BCOAPO Information Request No. 1.1.1 Dated: 07 December 2004 BC Hydro Response issued 20 December 2004	Page 1
British Columbia Hydro and Power Authority Call for Tenders for Capacity on Vancouver Island Review of Electricity Purchase Agreement

**Selected Tender Rate Compared to Tier 2 and No Award
(BCH Base Rate increased by 4.85% in F 2005, then 0%)**

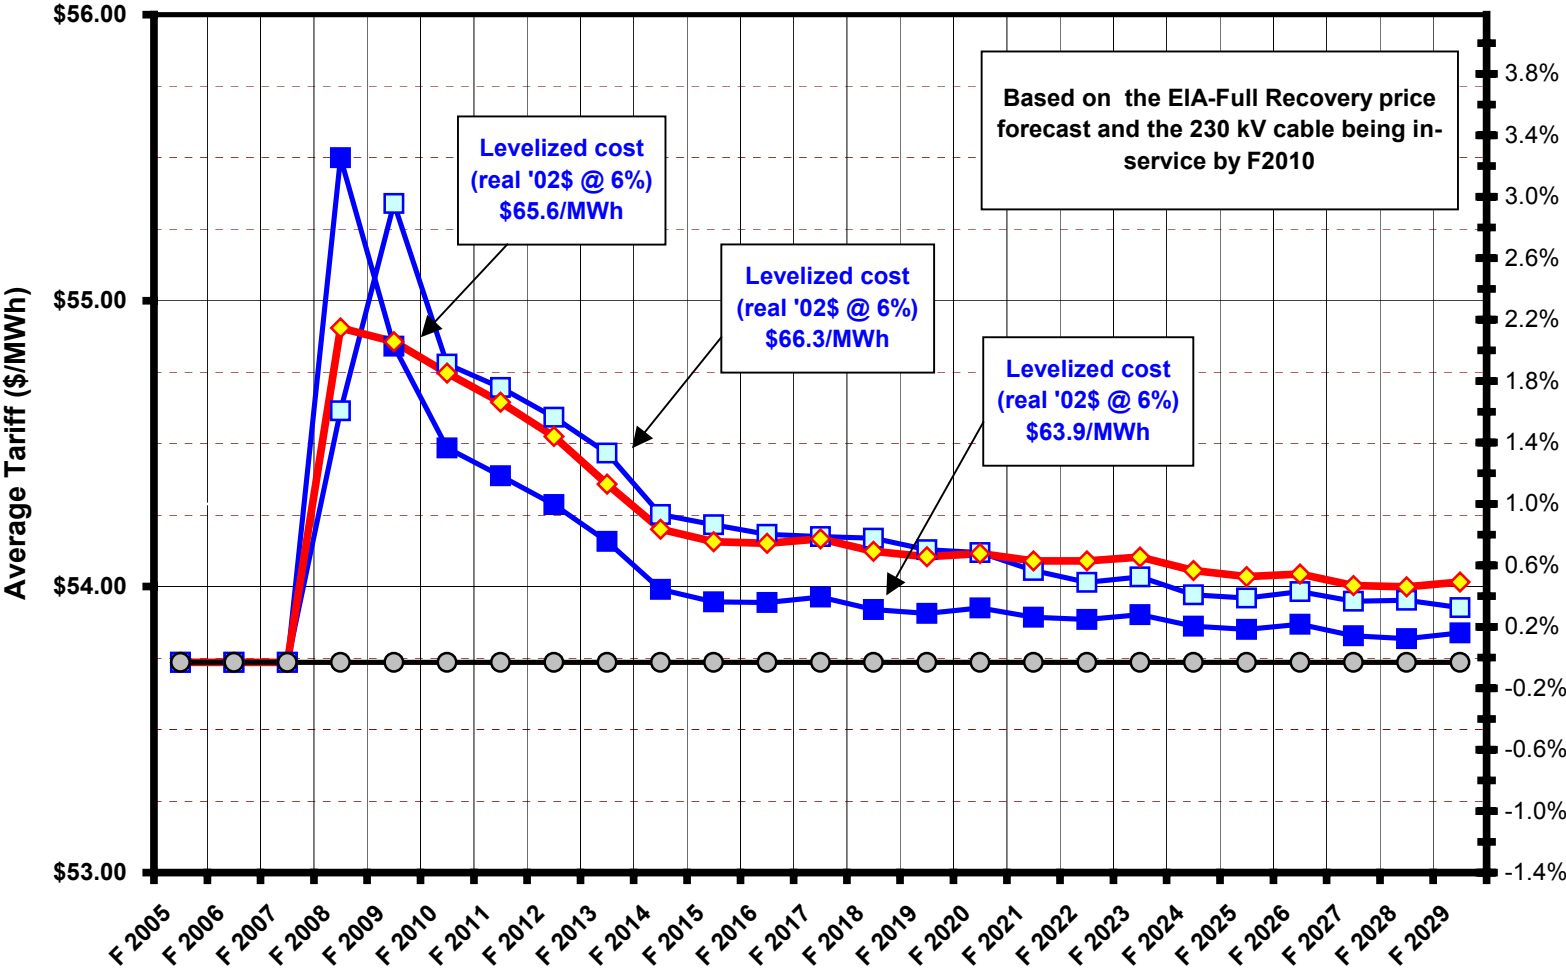
1.18.1 Was an incremental rate impact analysis conducted for either the Tier 2 or No Award cases? If so please provide the results in a format similar to Figure 2. If not, please provide a comparable rate impact analysis for the No Award case.

Attached is a chart providing the rate impact analysis for the Tier 1, Tier 2 and No Award scenarios in a format similar to Figure 2 contained in the *Report on the CFT Process*. A summary of the results is presented in the following table:

First Year Rate Impact	Levelized Cost (Real 2002\$ @ 6%)
Tier 1, Selected Tender	2.18%	\$65.6/MWh
Tier 2	1.64%	\$66.3/MWh
No Award	3.28%	\$63.9/MWh

- a) The chart does not reflect the cash flow arising from disposal of the VIGP assets, which would occur during calendar 2005. For Tier 1, the sales value of the VIGP assets is \$50 million whereas for the Tier 2 and No Award cases, the assumed salvage value is \$14 million.
- b) If the in-service date of the 230 kV AC cable is delayed beyond F2010, additional bridging supply will be required for the Tier 2 and No Award scenarios resulting in higher costs and additional non-quantitative risks/uncertainties relative to the Tier 1 option.
